Addendum #1

11/21/22

**project: Intermountain Healthcare
Layton Hospital – CT Remodel
201 Layton Parkway
Layton, UT 84041**

PROJECT: Layton Hospital CT Addition.

3
G001 **LEVEL 3 PLAN CODE PLAN**
 scale: 1/8" = 1'-0"

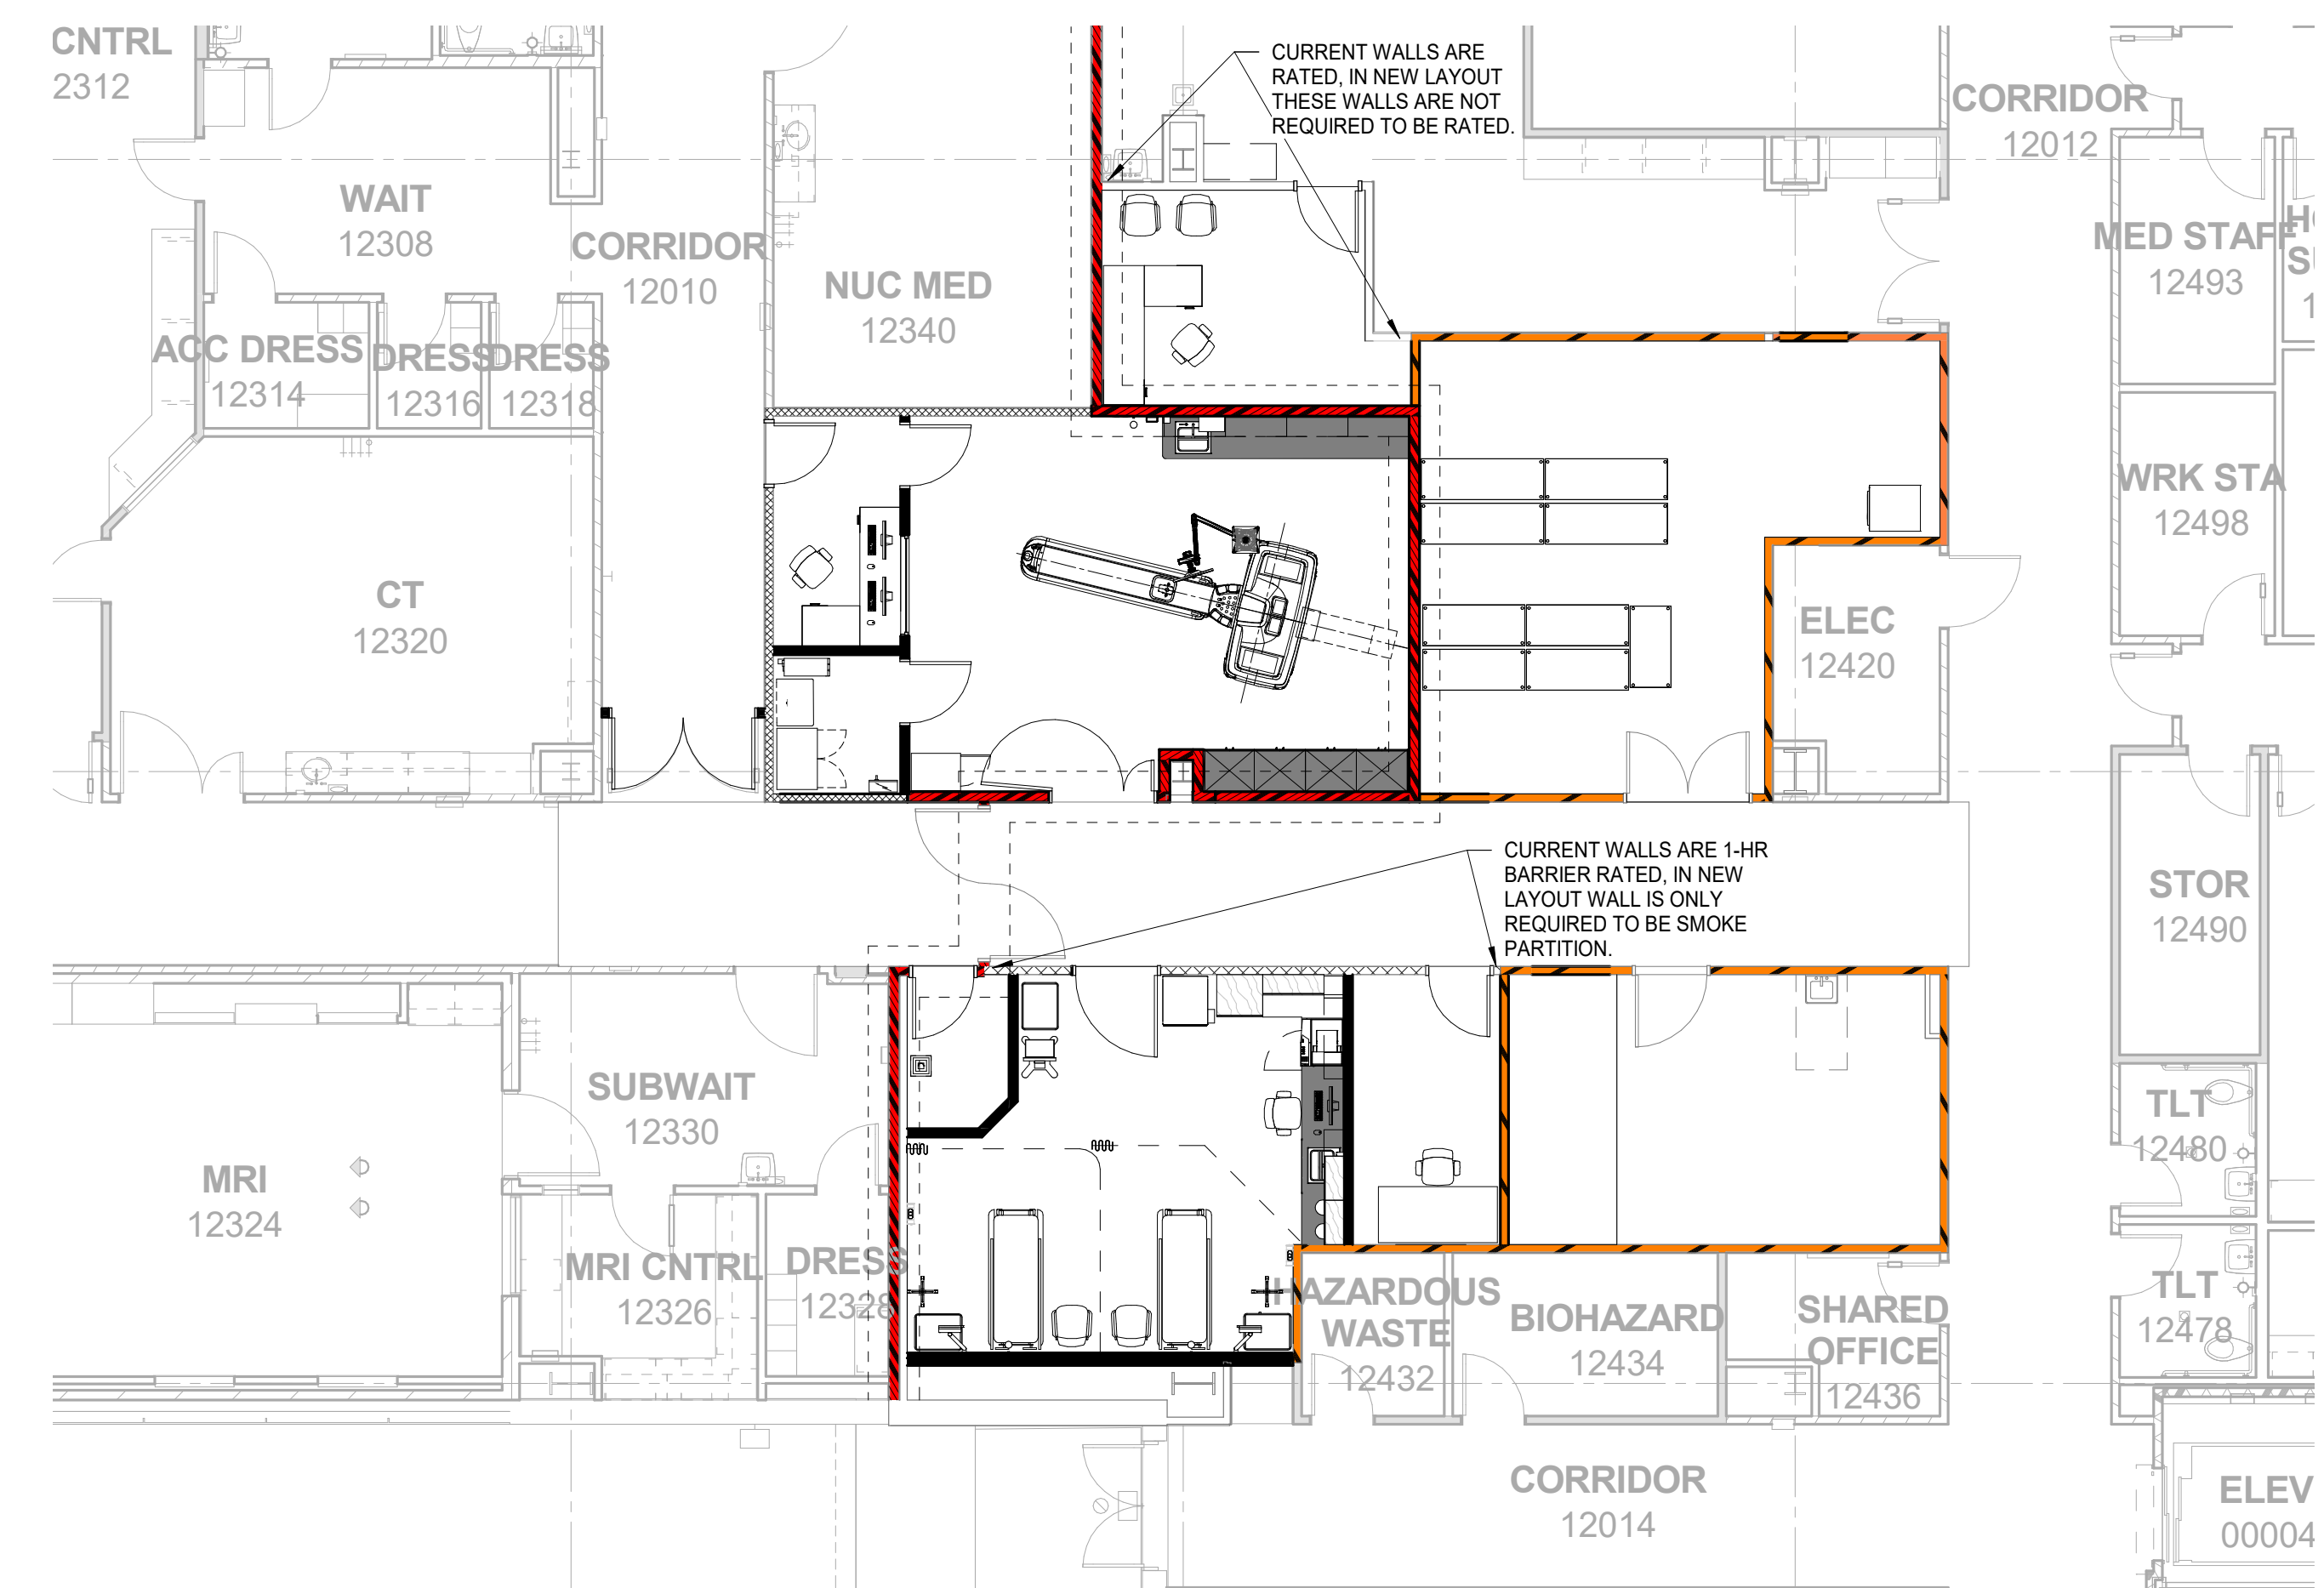
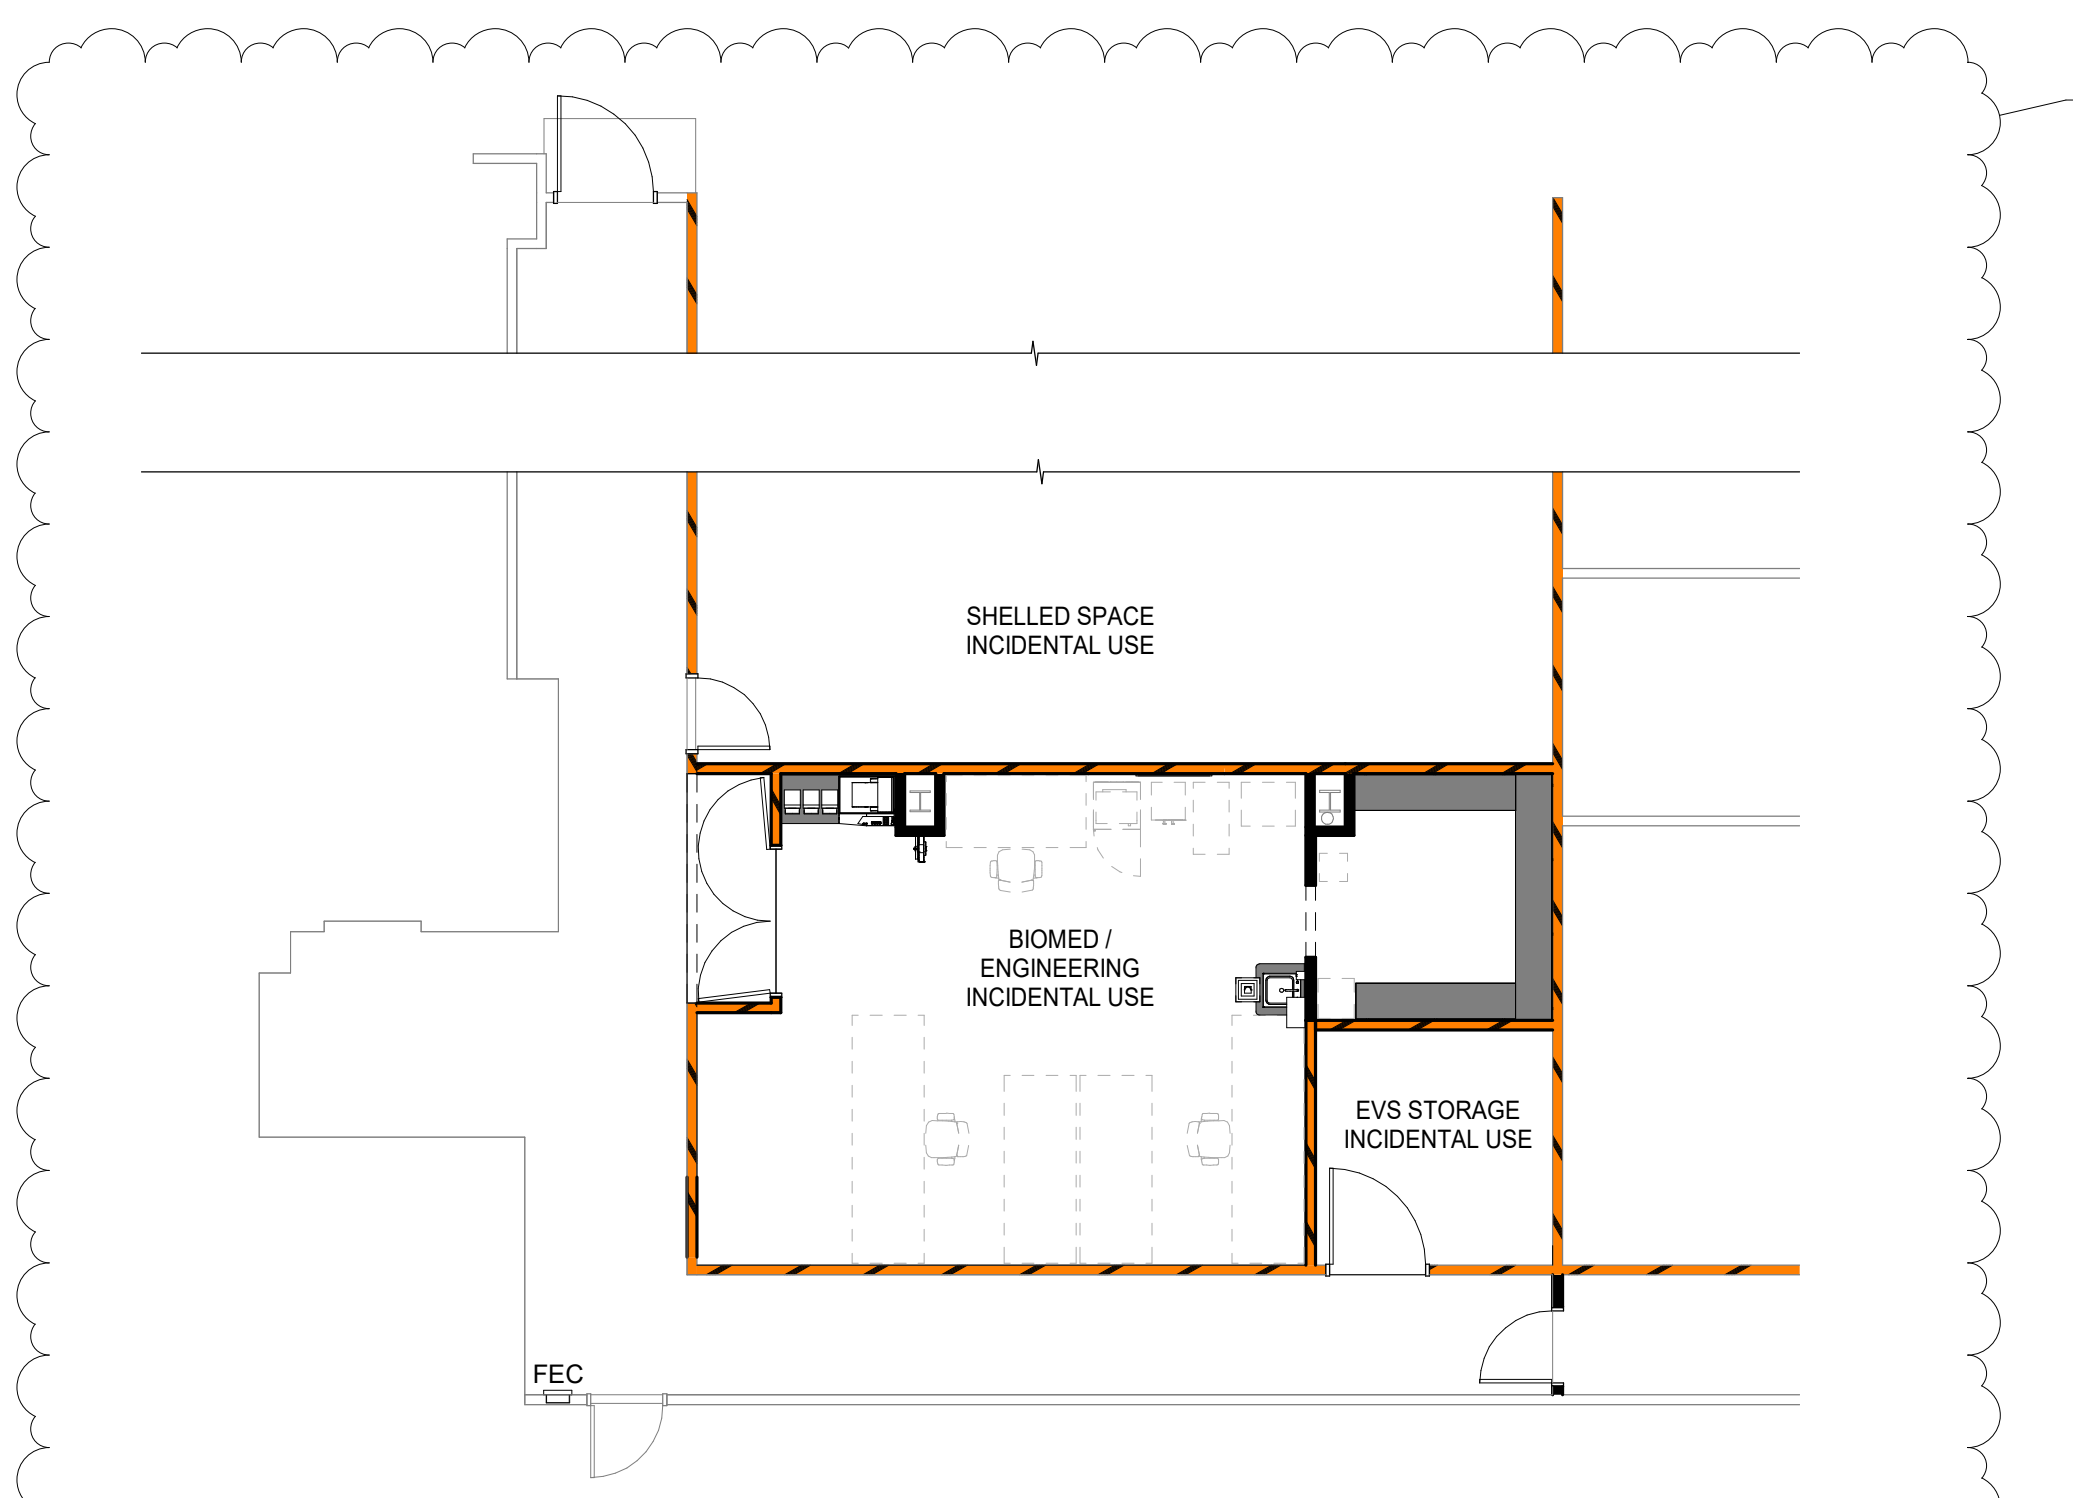
2. The State Department of Health gave review comments and is considering the bio-med/engineering room and the EVS storage room on the 3rd floor an incidental use. As such they need to be 1 hour fire rated.. The following changes to the plans have been made.

- a. Added a code plan for the 3rd floor on sheet G001 Code Diagrams to clearly show which walls are rated.
 - b. Removed note 2.09 on A103 Level 3 Plan, calling for the stencils to be blacked out on existing walls, as these existing walls will still need to be rated now.

1 LEVEL 3 PLAN
 A103 scale: 1/4" = 1'-0"

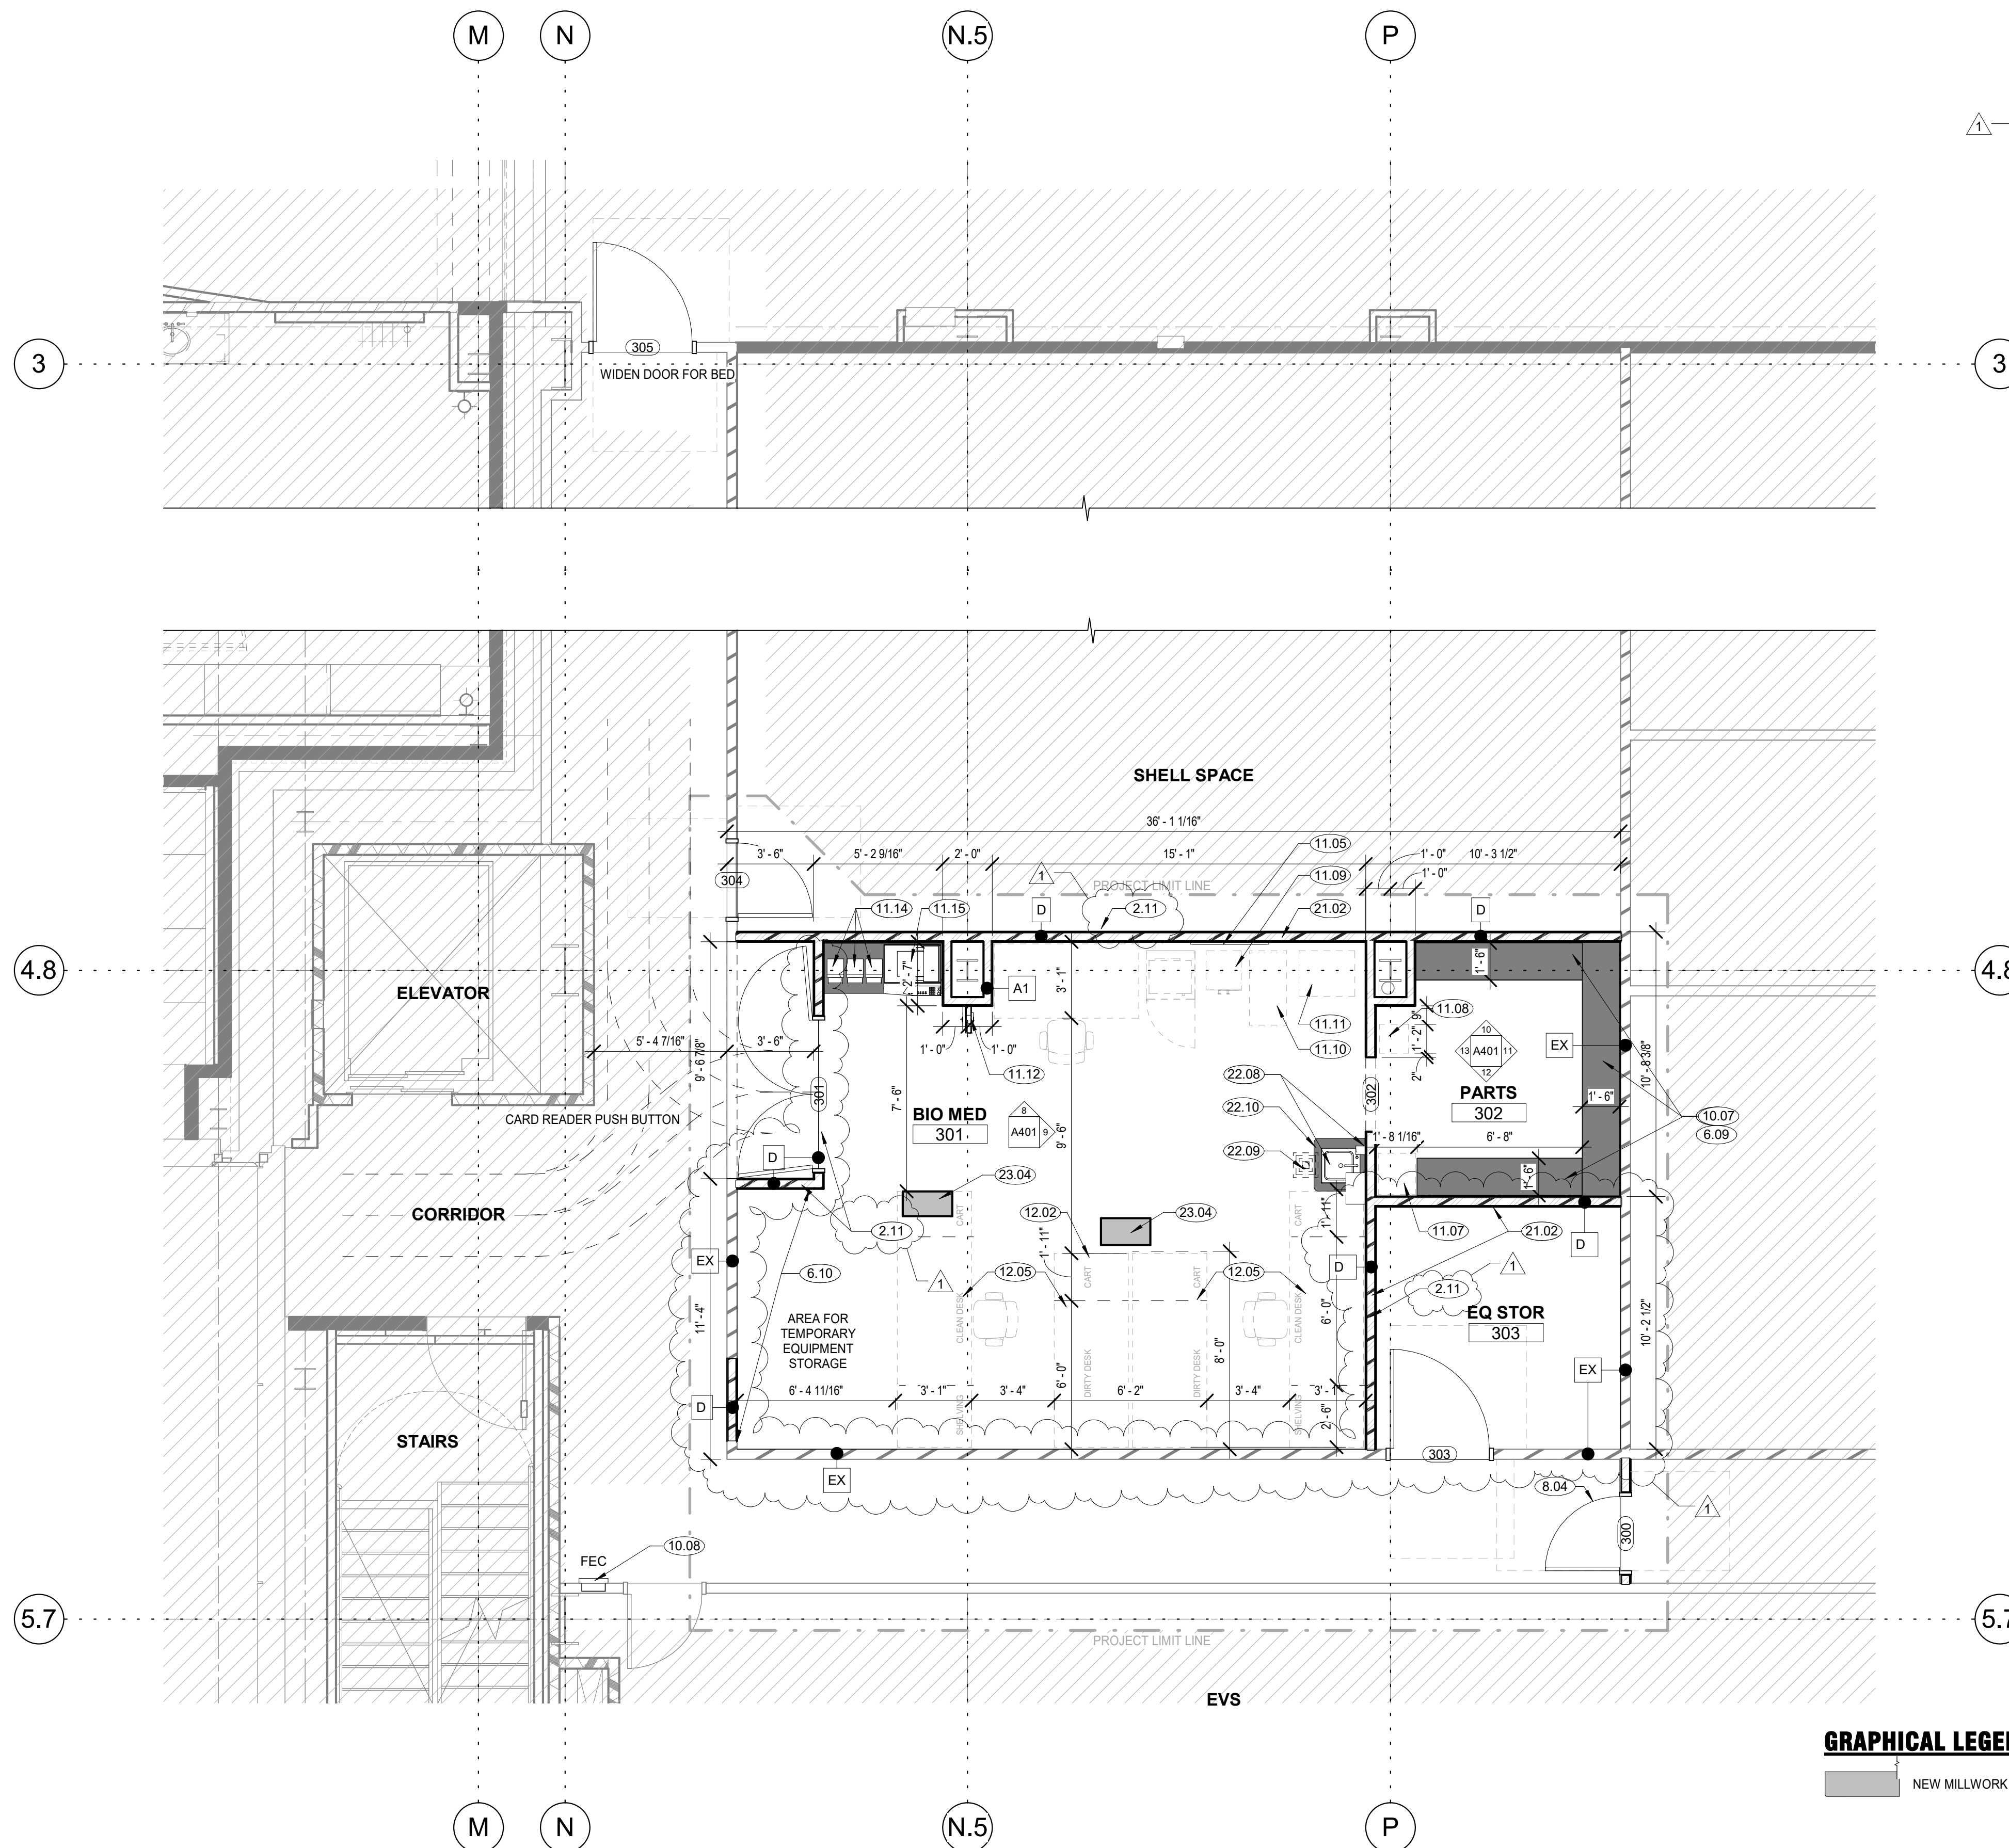
- c. Added note 2.10 calling for stenciling on walls that don't currently have the stencils on A103 Level 3 Plan
 - d. Changed wall hatch and wall type call out for walls that are now fire rated walls, on A103 Level 3 Plan.

- 2.11 STENCIL ABOVE CEILING ON GYPSUM BOARD, IN RED LETTERS 3" TALL MIN. WITH 3/8" STROKE, "1 HOUR FIRE BARRIER, PROTECT ALL OPENINGS". APPLY STENCIL WITHIN 15' OF THE END OF EACH WALL AND NOT MORE THAN 30' BETWEEN STENCILS.
